Subject: Applicant's Response to Data Requests, Set 2A (#155-172)
Rio Mesa Solar Electric Generating Facility (11-AFC-04)

Applicant's Response to Data Requests, Set 2A (Nos. 155-172)

Rio Mesa Solar Electric Generating Facility (Rio Mesa SEGF)

(11-AFC-04)

CDFG POTENTIAL WATERS OF THE STATE
ELEVATIONS & SPOT CHANNEL WIDTHS
RIO MESA SOLAR
ELECTRIC GENERATING FACILITY

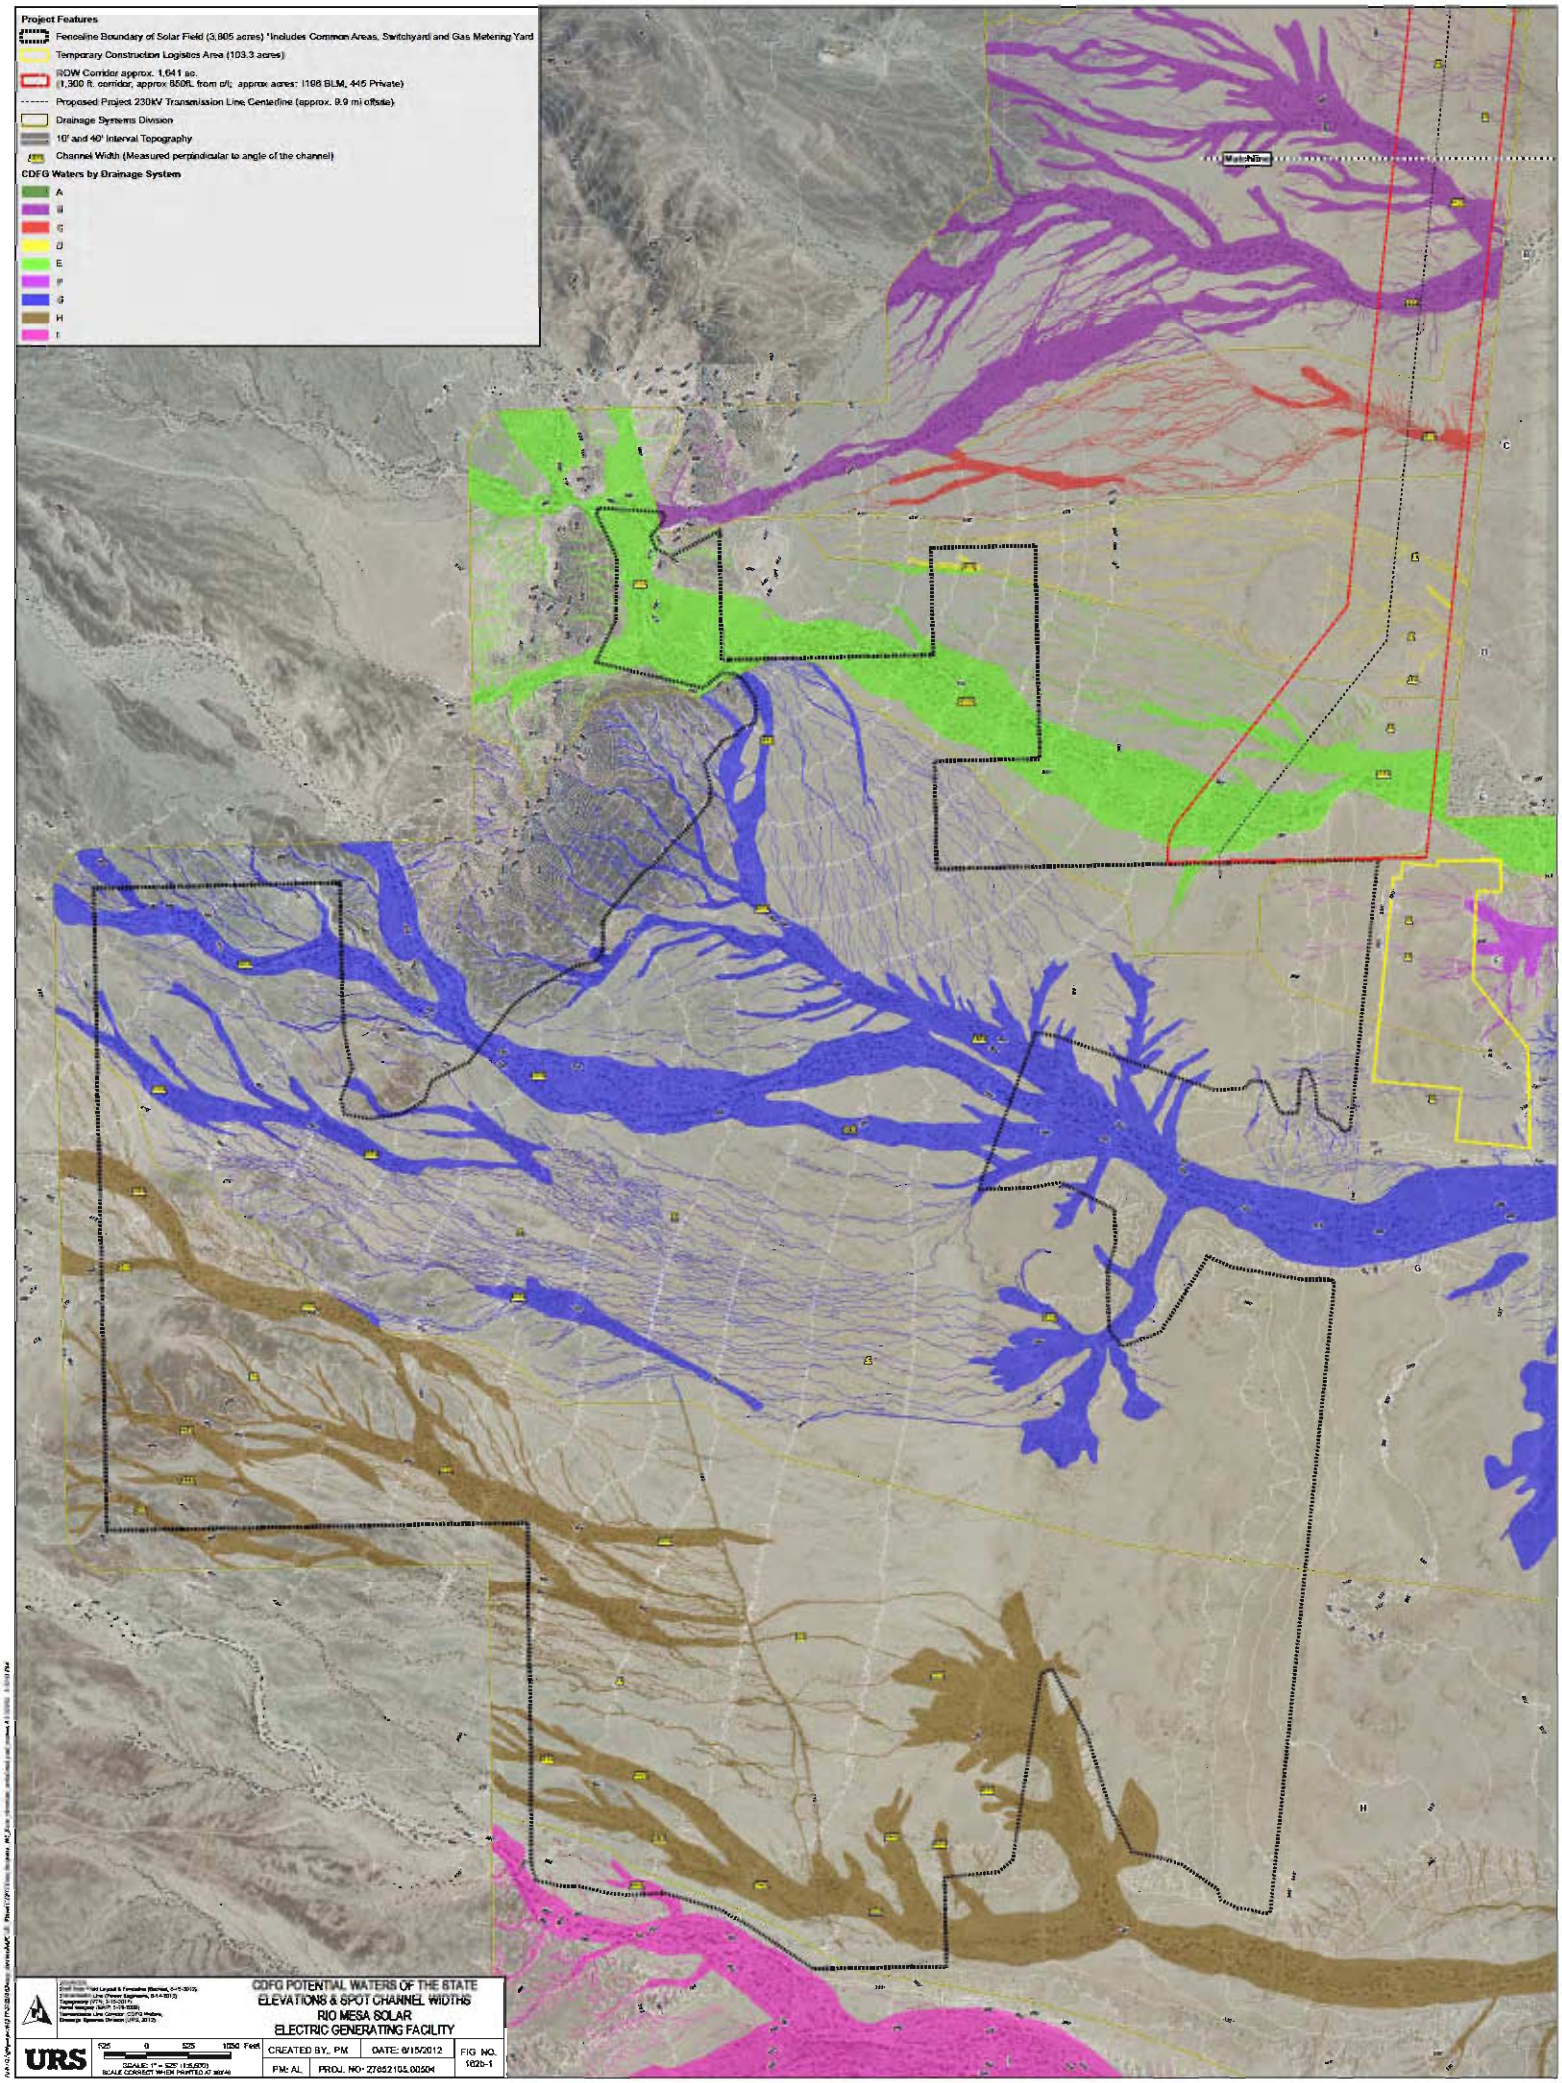
162. In a 1:3,600 or finer scale map, please show:

a. The project footprint and outline of any project related disturbance areas; and
b. Numerical values of elevation contour lines and widths of jurisdictional features.

162b: Two e-sized plots (Attachment 162b-1 covering the main project site and Attachment 162b-2 covering the transmission line corridor) of the numerical values of elevation contour lines and widths of jurisdictional features.

Rio Mesa Solar - Disturbed Areas

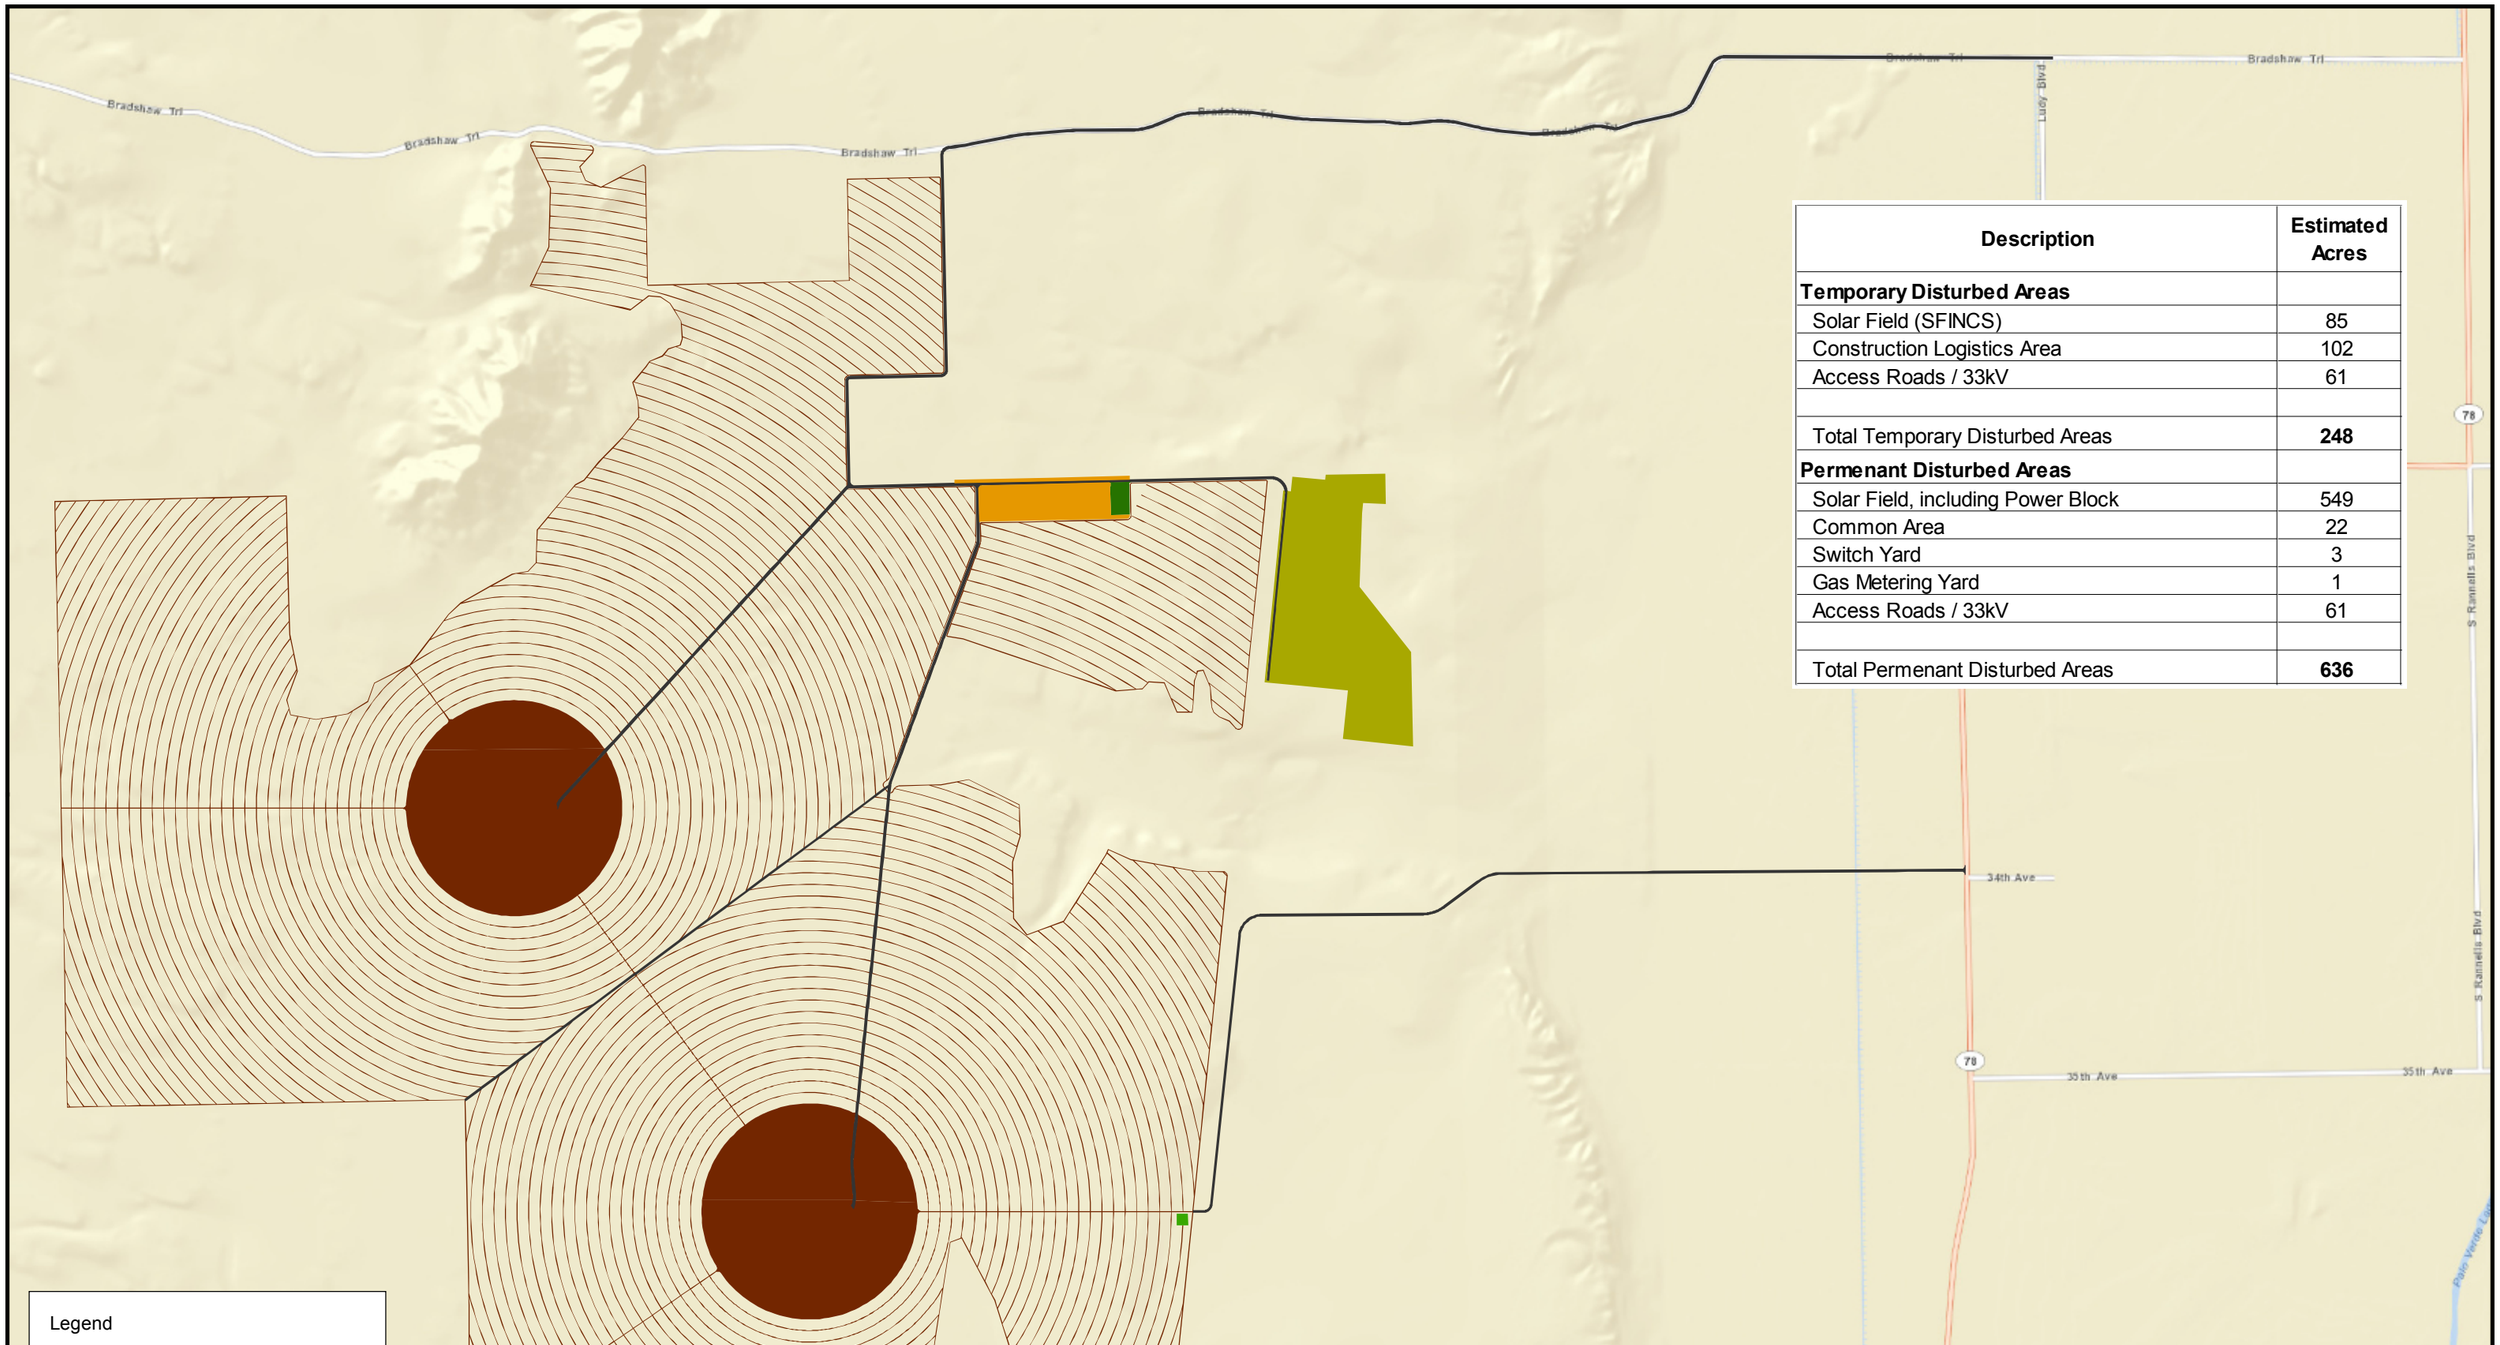
166. Please identify all areas that would be graded for construction of the proposed project. Illustrate these areas on a map.

Attached are two maps (Attachments DR 166-1 and DR 166-2). The first map (Attachment DR 166-1) shows the proposed project area including the access roads and temporary Construction logistics area. The second map (Attachment DR 166-2) shows the temporary and permanent disturbances affected by the proposed 220KV Gen-tie transmission line, this also map shows the temporary construction lay-down and cable pulling/stringing areas.

The total temporary disturbed area for the Project is mainly attributed to approximately 85 acres throughout the solar field that will be used for trenching for the power and communication service cables that are associated with the Solar Field Integrated Control System (SFINCS) which will control all the Heliostats as well as other ancillary equipment such as calibration cameras, Met stations and Access points. In the case of a wired heliostat ctrl system the cables from the Access points (or CPDU) to each individual heliostat will be run on the surface of the ground and thus will not be a disturbance.

The applicant estimates the total temporary disturbance area to be approximately 248 acres. This includes the Solar field mentioned above, the Construction Logistics Area (CLA) located east of the WAPA transmission line, the access roads and 33Kv overhead electrical service, plus an additional approximately 30 acres for the Gen-tie line construction lay-down and cable stringing/pulling areas.

The area of Permanent Disturbance totals approximately 636 acres on the main project site, and access roads. This number includes all permanent features associated with the site access roads, Solar Fields, the Power Blocks, and Common Facilities areas. In addition to the 636 acres above, an additional approximately 16 acres will be attributed to the Gen-tie, its service road and pole structure foundations.
